CONSTRUCTION OF MODERN AT GRADE WALKWAYS AND BEAUTIFICATION ON BOTH SIDES OF SHIHAB THANGAL ROAD AT PANAMPILLY NAGAR AS A PART OF KMRL NON-MOTORISED TRANSPORT INITIATIVE

KMRL/PRJ/PNGR/224/2015/TEN 09

ADDENDUM 1 – 13/11/2015

Section 6– Drawings

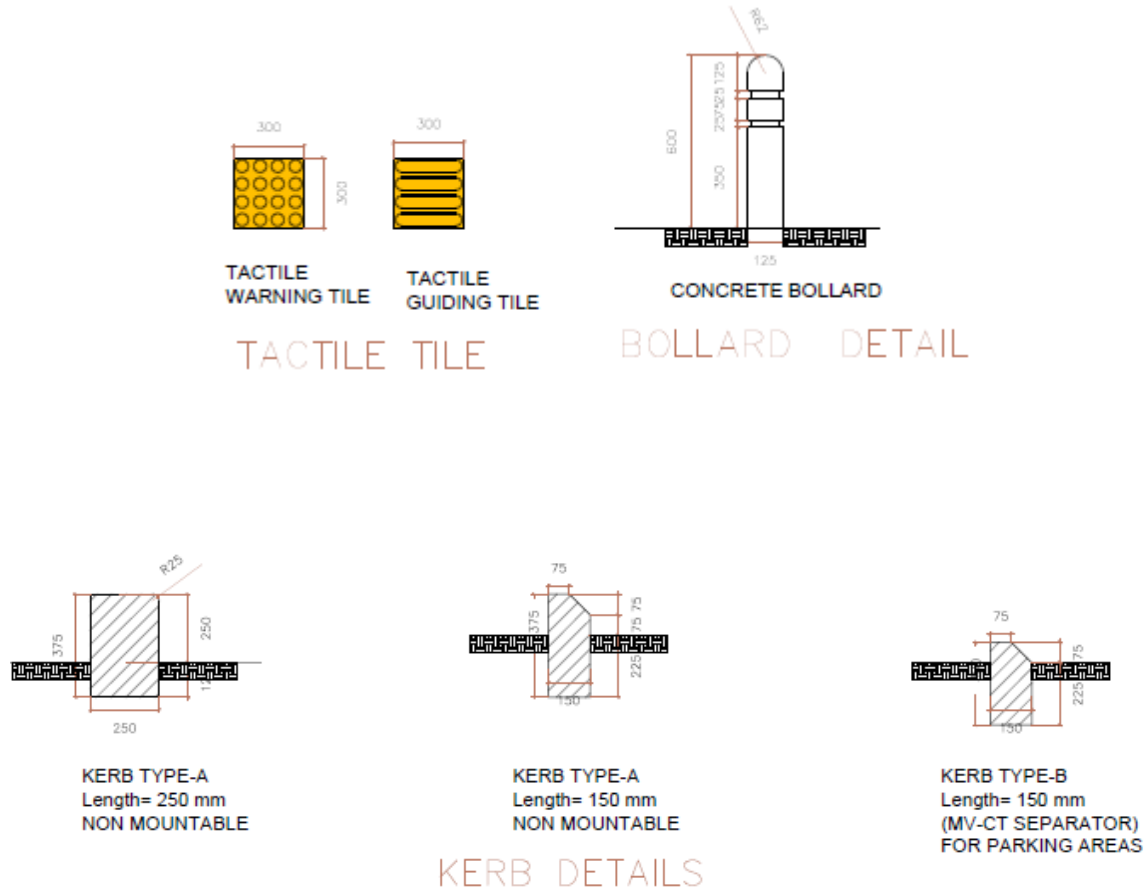
The following typical drawings may be added along with the Section Drawings:
